# Service Bulletin

NO. 325

## Studebaker and Packard Clipper

Fig. 1

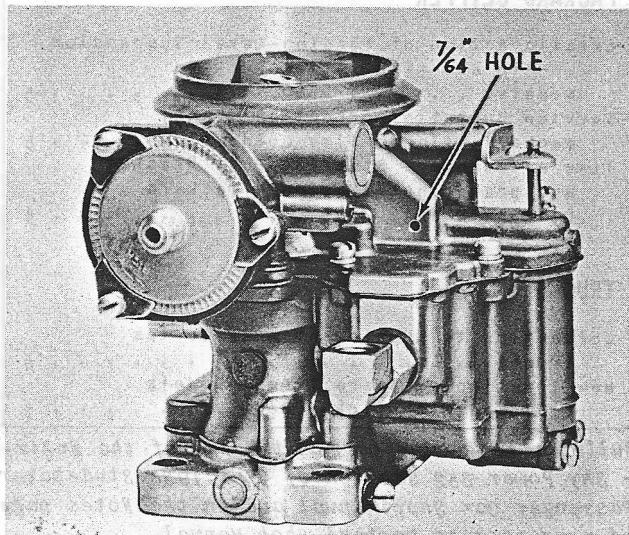
1. Remove the carburetor air chamber cover and remove the carburetor from the engine.
2. Drill a  $7/64$ " hole into the vent passage at the location shown in Fig. 1. Then, drill two  $5/64$ " holes in the throttle body at the locations shown in Fig. 2. It is not necessary to disassemble the carburetor to drill the holes but care should be taken to prevent chips from entering the carburetor.
3. If the air chamber cover does not have a

Fig. 3

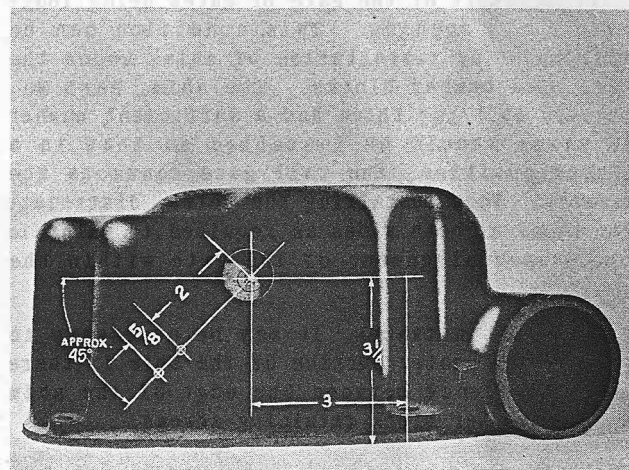
vent valve (flapper valve) locate and drill a 1" hole and two  $5/32$ " holes in the air chamber cover at the locations shown in Fig. 3. Install the Air Chamber Vent Valve Assembly, Part No. 1542765 in the cover (see Fig. 4), placing two small flat washers be-

tween the spring and the cover and using two self-tapping screws, Part No. G453113. After the valve is installed, bend the spring as required to obtain an opening of 1/4" between the cover and the highest point at the outer edge of the valve.

Fig. 5

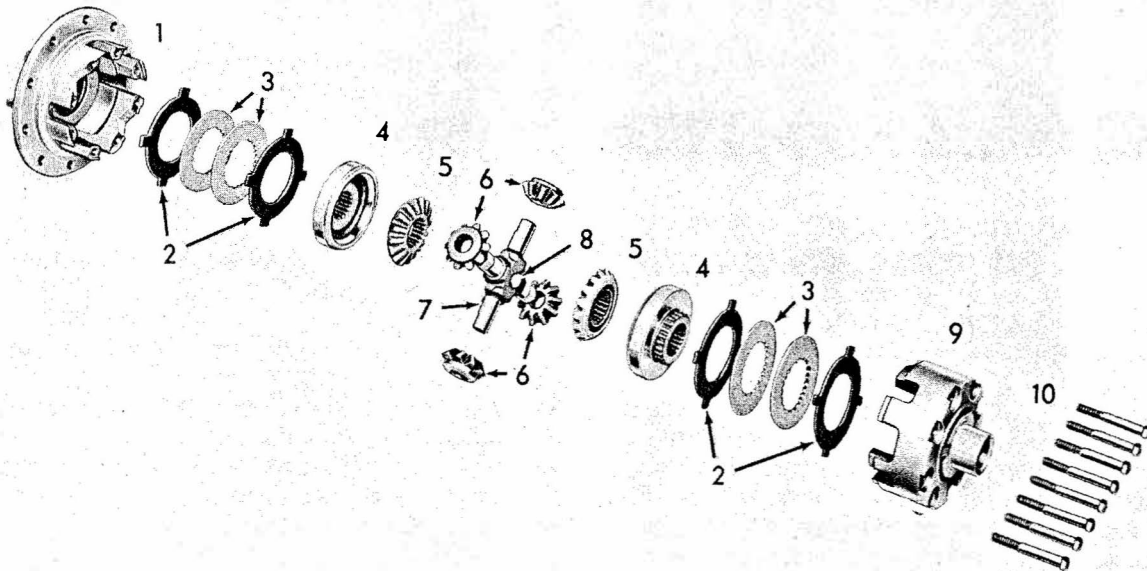
A change has been made in the Twin-Traction differential; the cone-type clutches have been replaced by disc-type clutches. Fig. 5 illustrates the exploded view of the latest type.

The disassembly and reassembly procedure with the exception of the clutches is the same for both types. When reassembling the disc type, the lugs of the plates are placed in the notches provided in the housing. Note the relationship of the discs to the plates; the two friction discs are placed between the plates.

Fig. 7

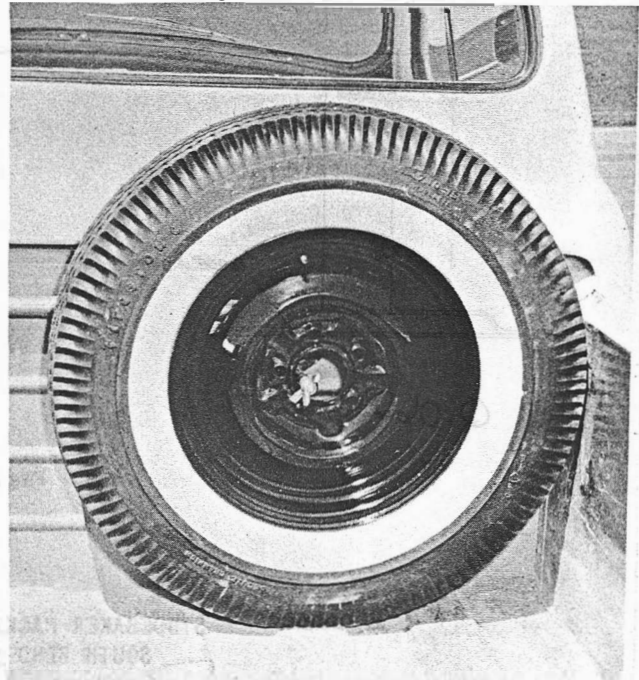
Recently a new location for the spare tire was released as a factory installed option for trucks equipped with a pickup body. At the optional location, the tire is mounted at the front wall of the body (see Fig. 7). This can very readily be adapted to prior models for owners desiring this "in the box" location.

Fig. 8

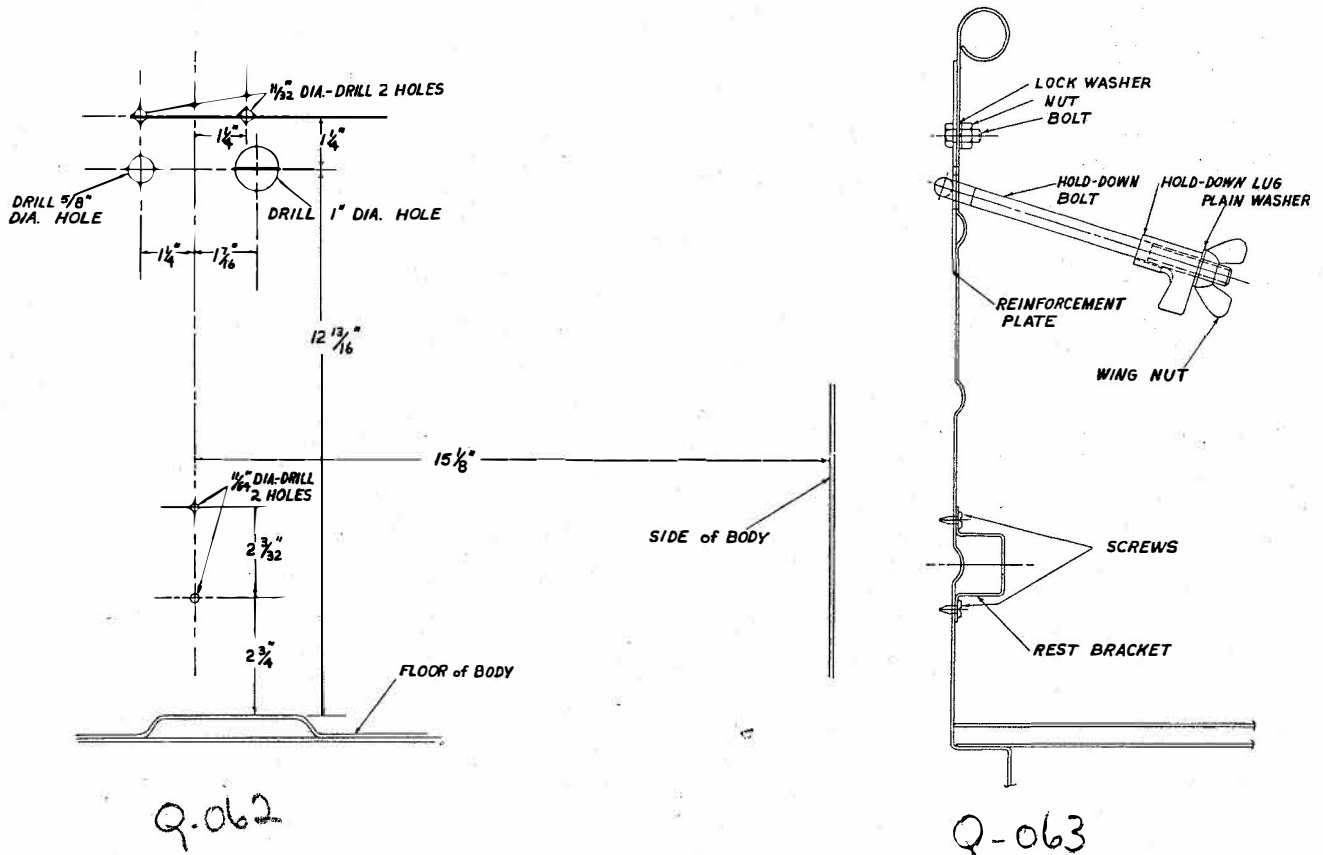
Drill the front wall of the pickup body at the locations indicated in Fig. 8. Install the reinforcement plate and install the hold-down bolt in the lower set of holes. Drill two holes for the rest bracket retaining screws at the locations shown in Fig. 8 and install the bracket.
